Form 3160-5  
(June 2019)UNITED STATES  
DEPARTMENT OF THE INTERIOR  
BUREAU OF LAND MANAGEMENTFORM APPROVED  
OMB No. 1004-0137  
Expires: October 31, 2021**SUNDRY NOTICES AND REPORTS ON WELLS**  
**Do not use this form for proposals to drill or to re-enter an abandoned well. Use Form 3160-3 (APD) for such proposals.**

8. Well Name and No. ALMOST EDDY 30 FED COM/512H

EOG respectfully requests an amendment to our approved APD for this well to reflect the following changes:

Change SHL from T-25-S, R-32-E, Sec 30, 1816' FSL, 2366' FWL, Lea Co., NM, to T-25-S, R-32-E, Sec 30, 2190' FSL, 1631' FWL, Lea Co., N.M.

Revised Wellbore A:

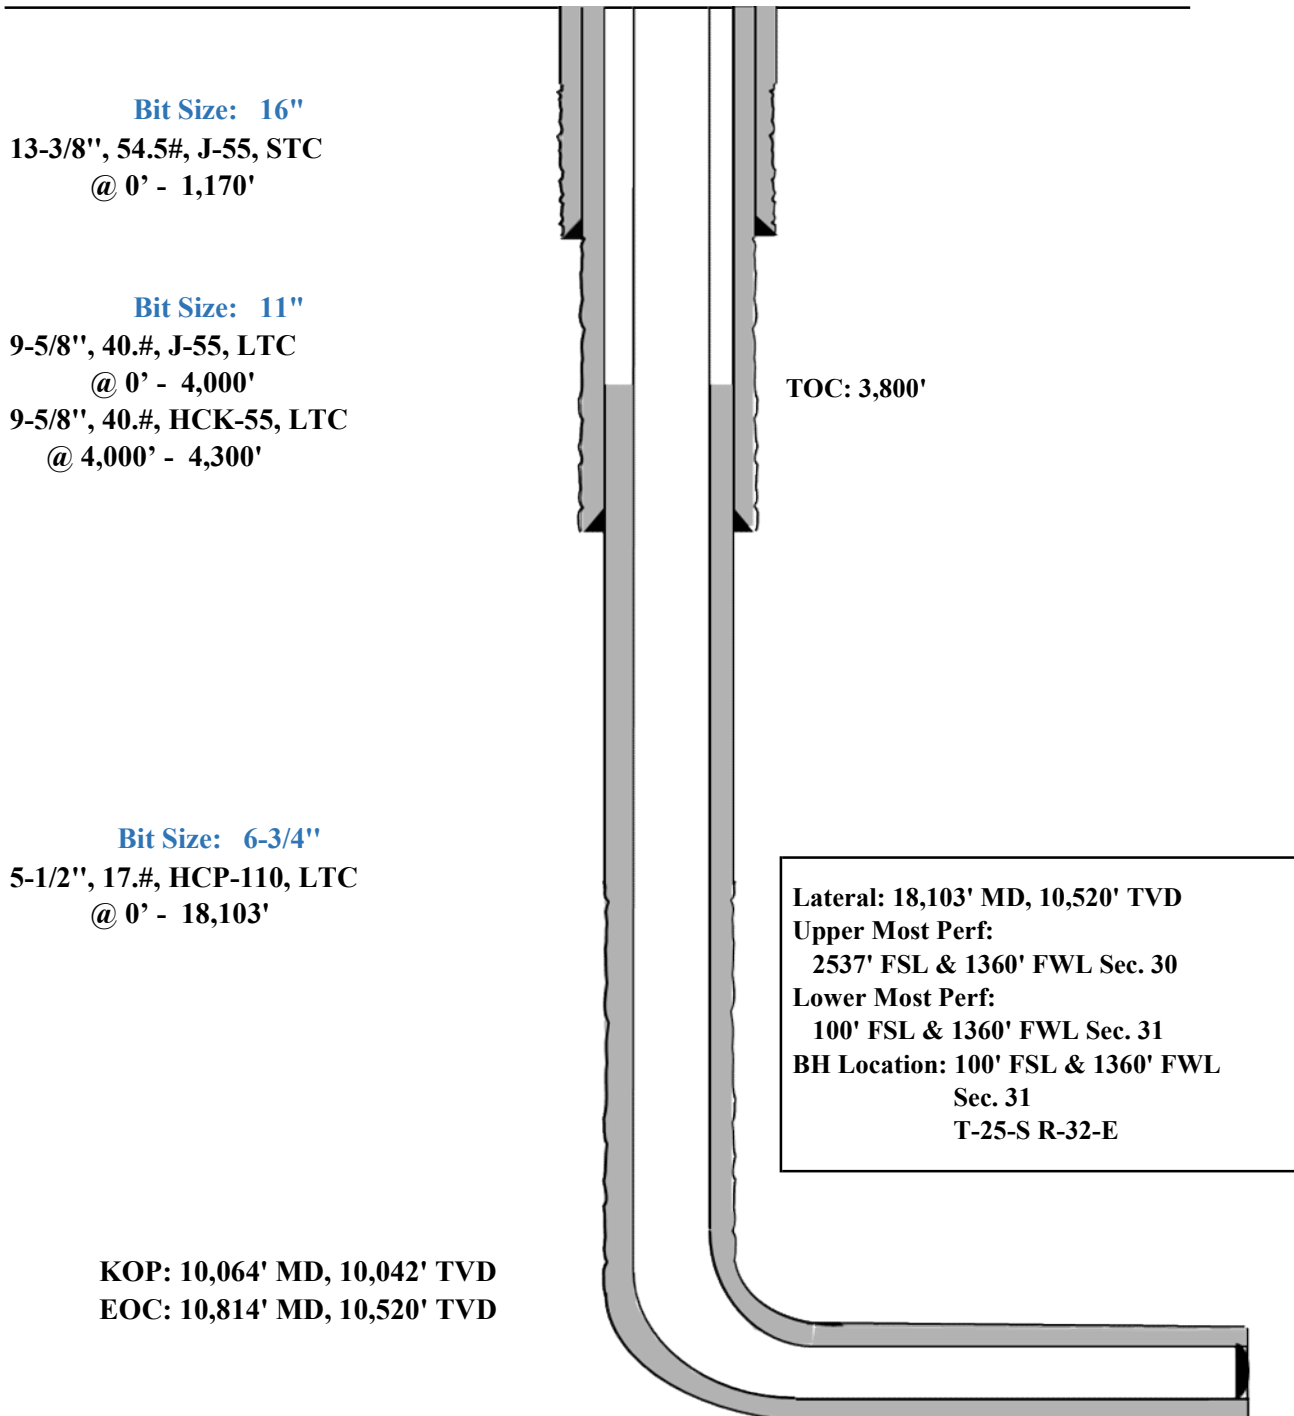
Update casing and cement program to current design.

## Proposed 11" Hole with 9.625" 40# J55/HCK55 LTC Casing

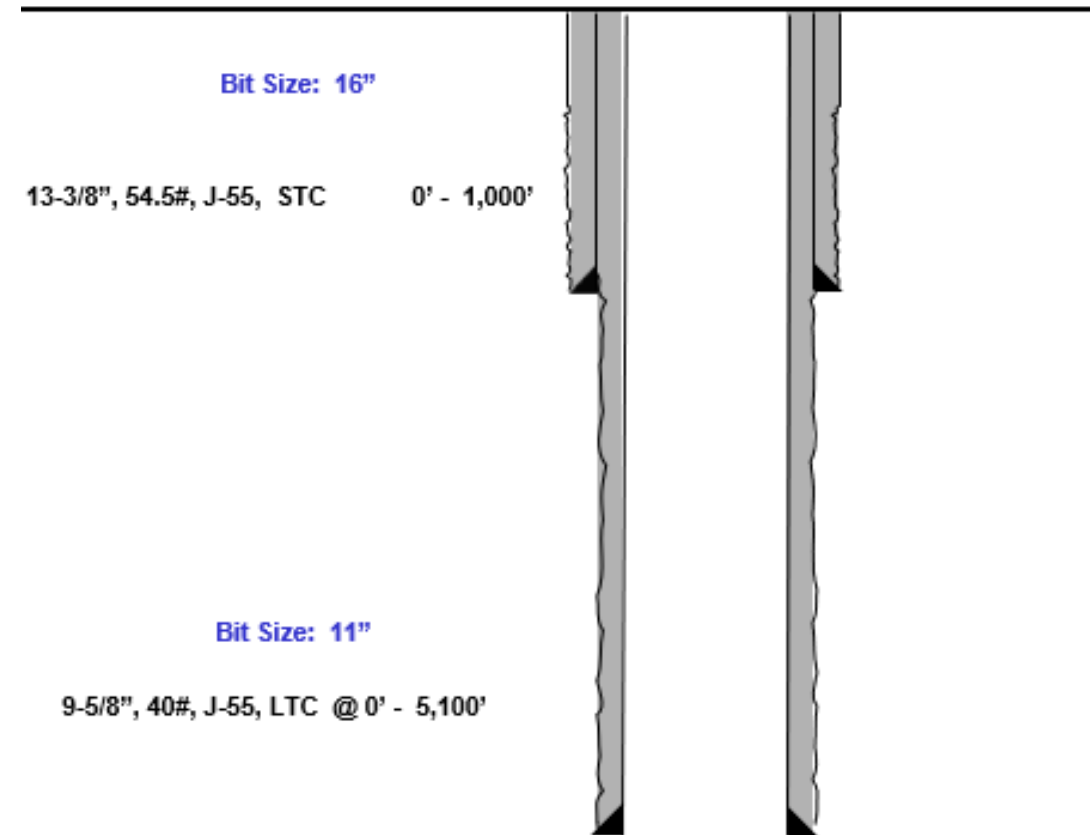
EOG requests permission to allow deviation from the 0.422" annulus clearance requirement for the intermediate (salt) section from Onshore Order #2 under the following conditions:

- 11" Bit + 0.52" Average hole enlargement = 11.52" Hole Size
  - 0.9475" Clearance to casing OD

$$= \frac{11.52 - 9.625}{2}$$
  - 0.4475" Clearance to coupling OD

## Proposed 9.875" Hole with 8.625" 32# J55/P110 BTC-SC Casing

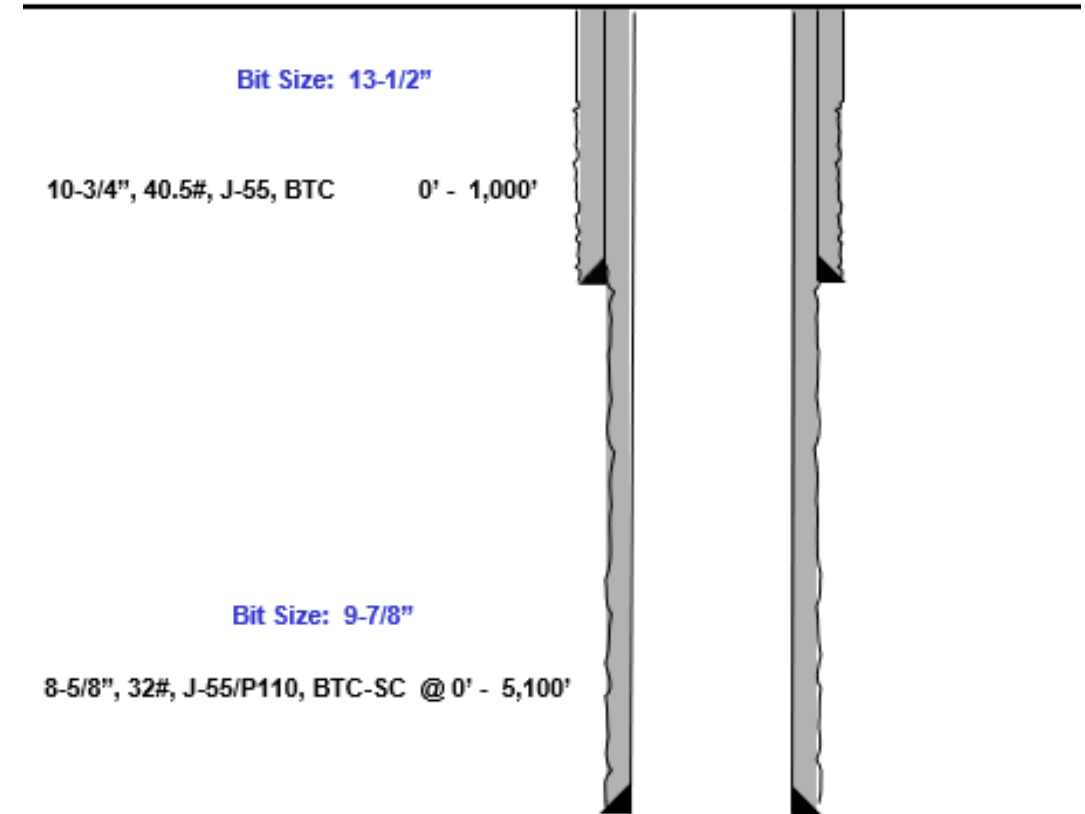
**EOG request permission to allow deviation from the 0.422" annulus clearance requirement for the intermediate (salt) section from Onshore Order #2 under the following conditions:**

- 9.875" Bit + 0.42" Average hole enlargement = 10.295" Hole Size
  - 0.835" Clearance to casing OD

$$= \frac{10.295 - 8.625}{2}$$
  - 0.585" Clearance to coupling OD
